PROJECT: OFFICE / WAREHOUSE

LOCATION: HAWKINS
ALBUQUERQUE, NM 87113

RESUBMITTAL COMMENTS

DRAINAGE / GRADING PLAN

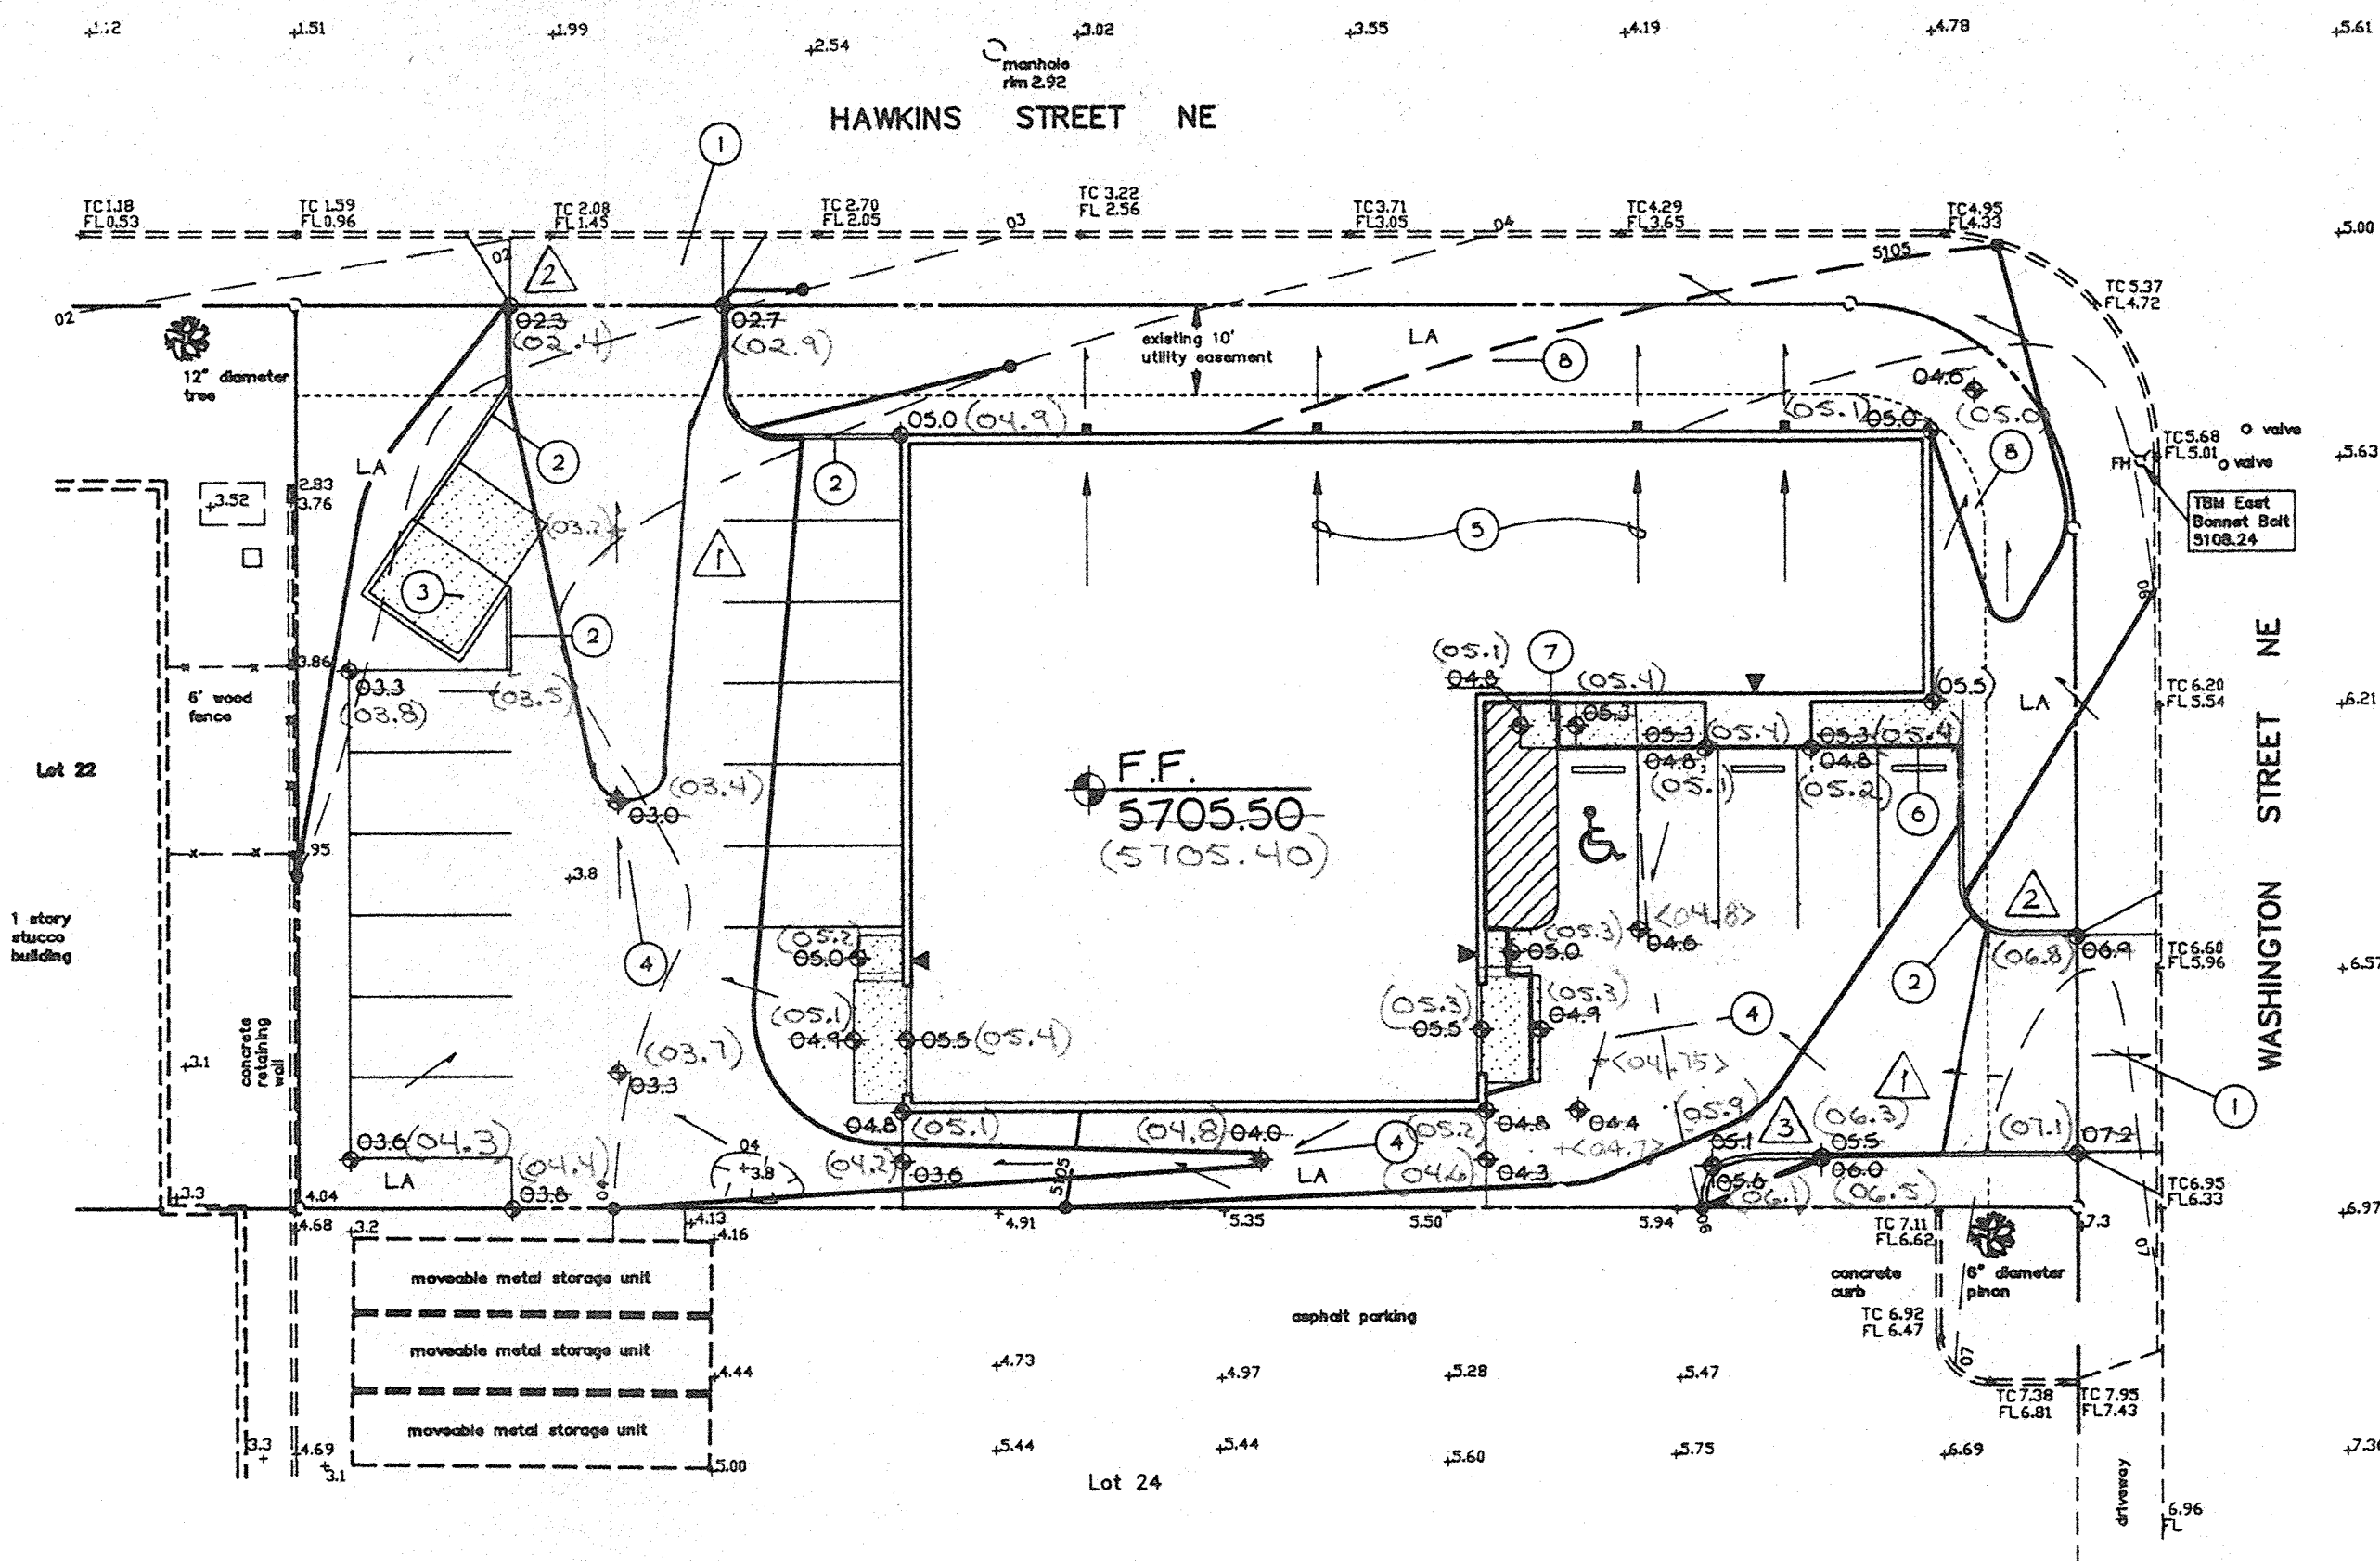
1. MINOR REVISIONS TO PARKING LOT GRADING TO ACHIEVE A MAX. GRADE OF 5%.
2. MINOR REVISION TO WATERBLOCK SPOT ELEVATIONS TO MAINTAIN A WATERBLOCK HEIGHT BETWEEN 10" AND 12" IN HEIGHT.
3. CURB ADDED TO SOUTHEAST LANDSCAPE AREA WITH SPOTS ADDED FOR CLARIFICATION.

DRAINAGE / GRADING PLAN

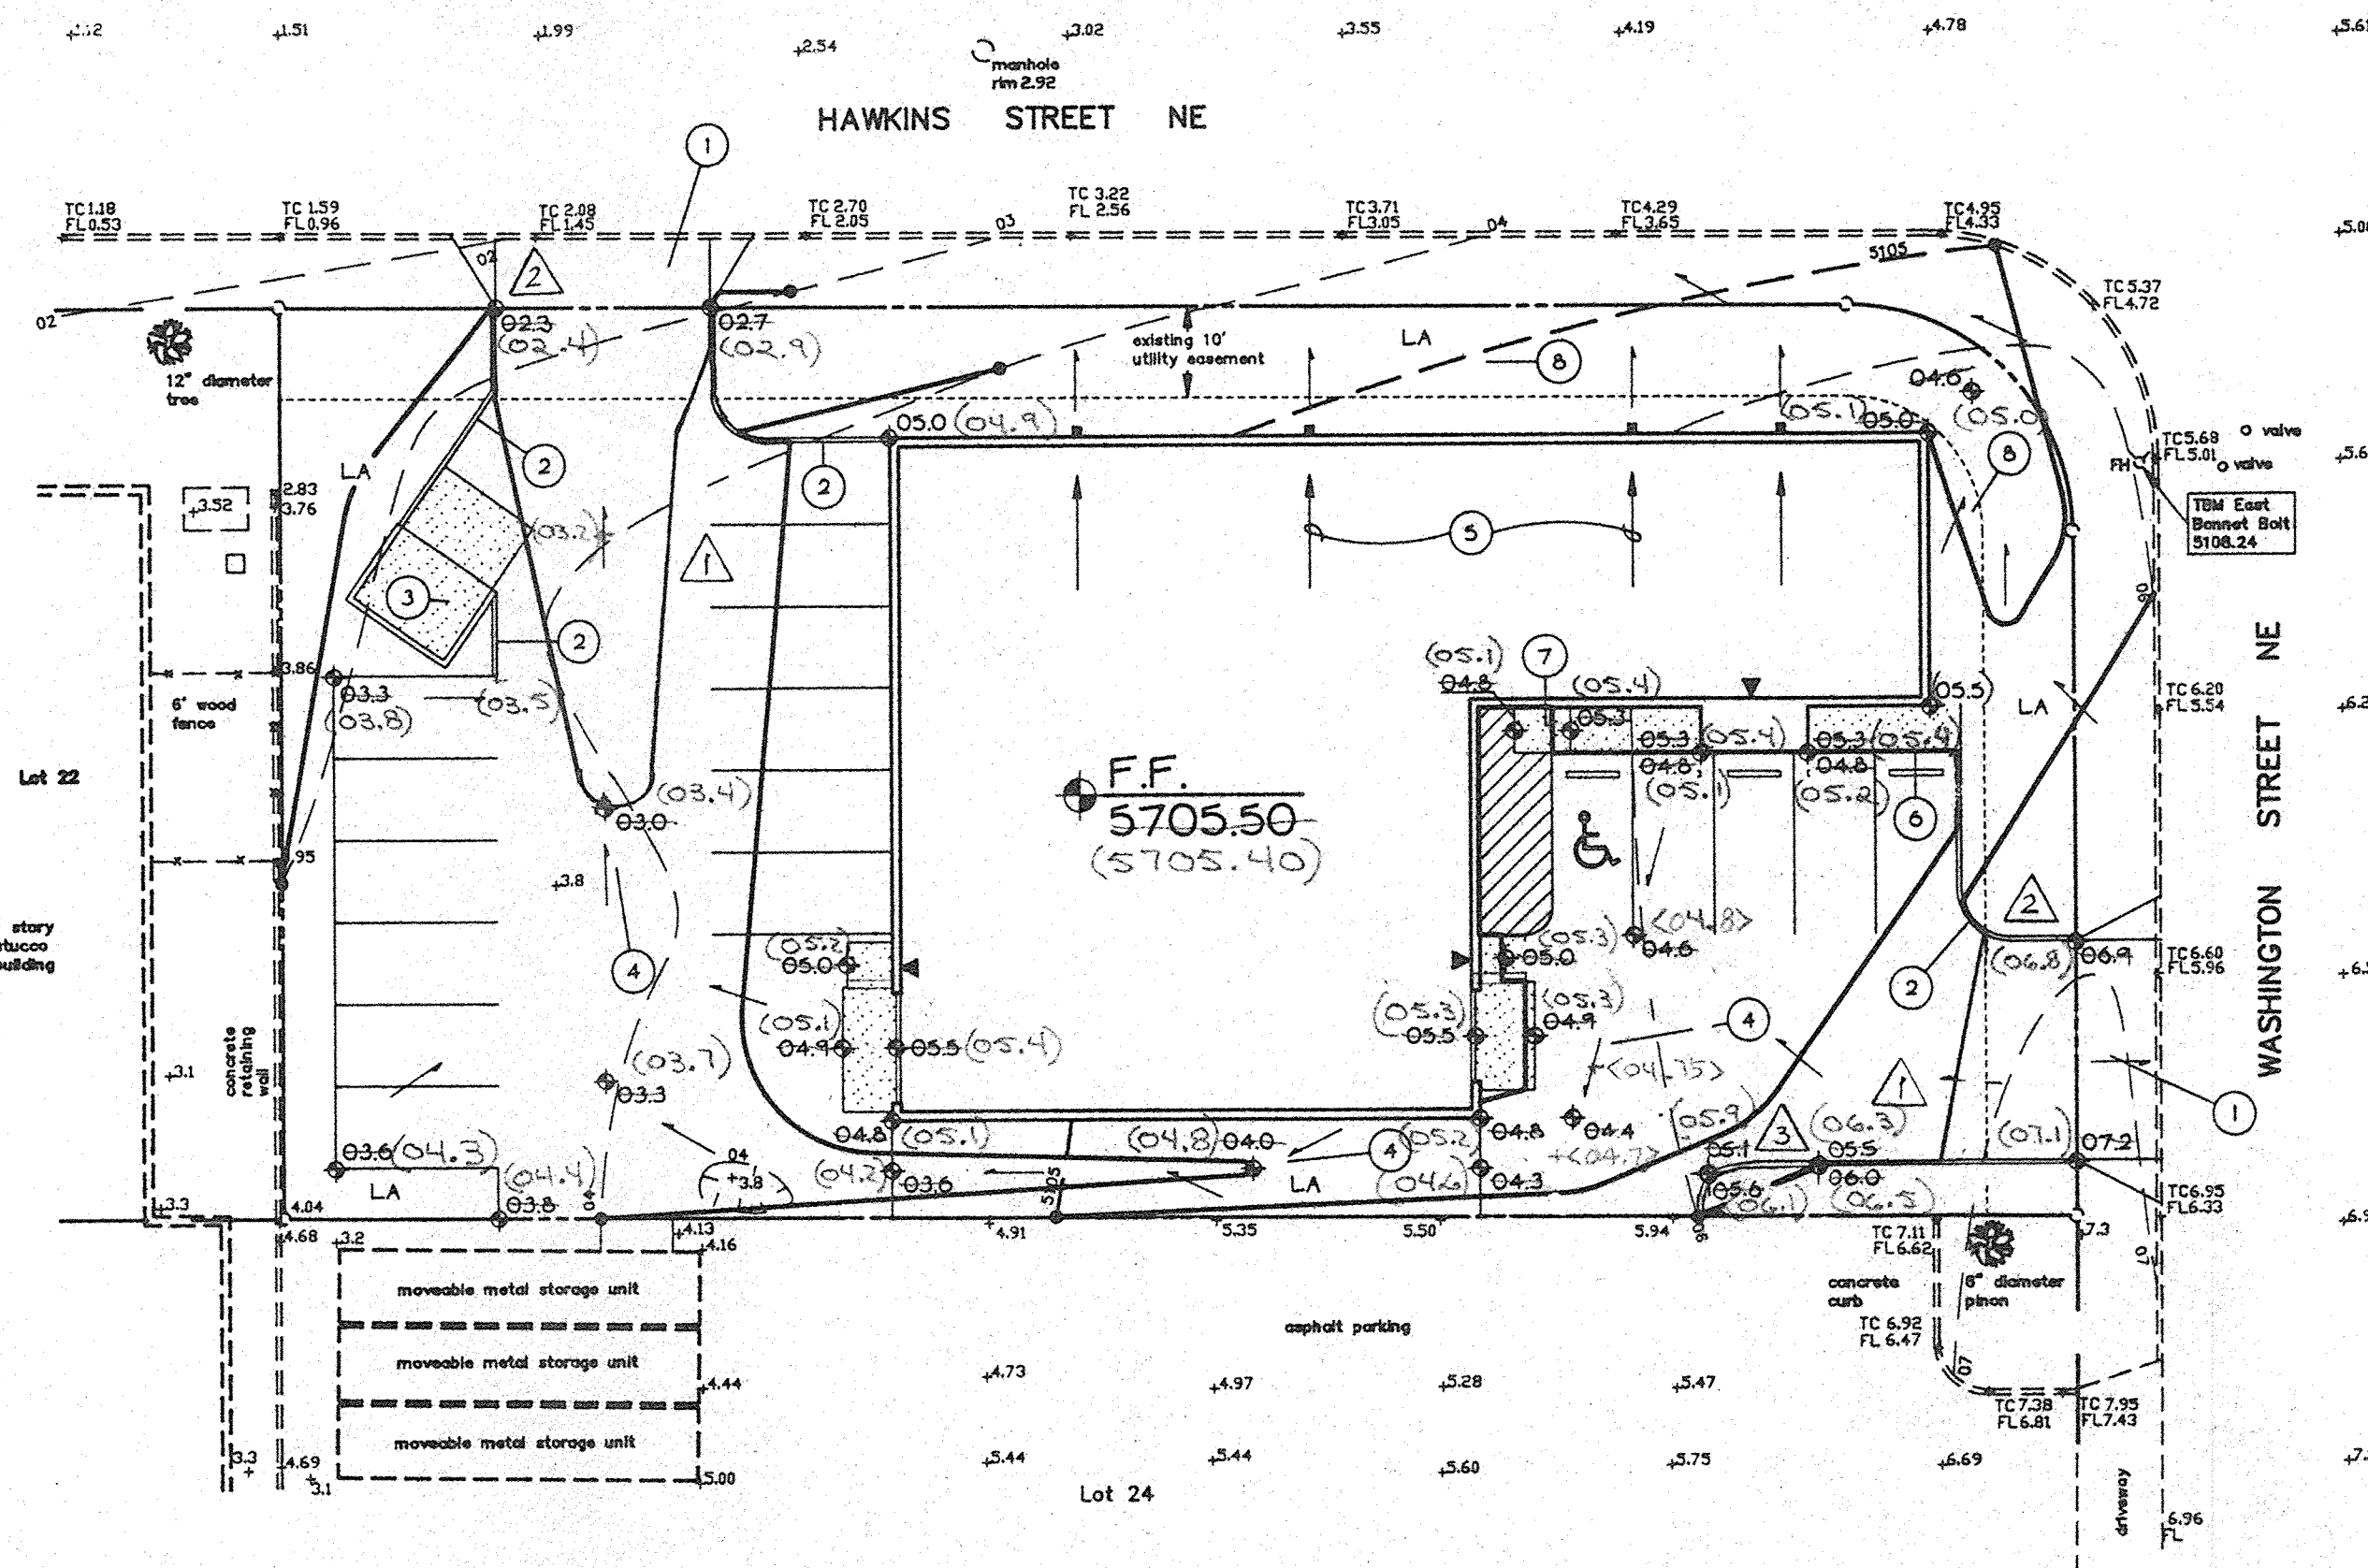
1. MINOR REVISIONS TO PARKING LOT GRADING TO ACHIEVE A MAX. GRADE OF 8%.
2. MINOR REVISION TO WATERBLOCK SPOT ELEVATIONS TO MAINTAIN A WATERBLOCK HEIGHT BETWEEN 10" AND 12" IN HEIGHT.
3. CURB ADDED TO SOUTHEAST LANDSCAPE AREA WITH SPOTS ADDED FOR CLARIFICATION.
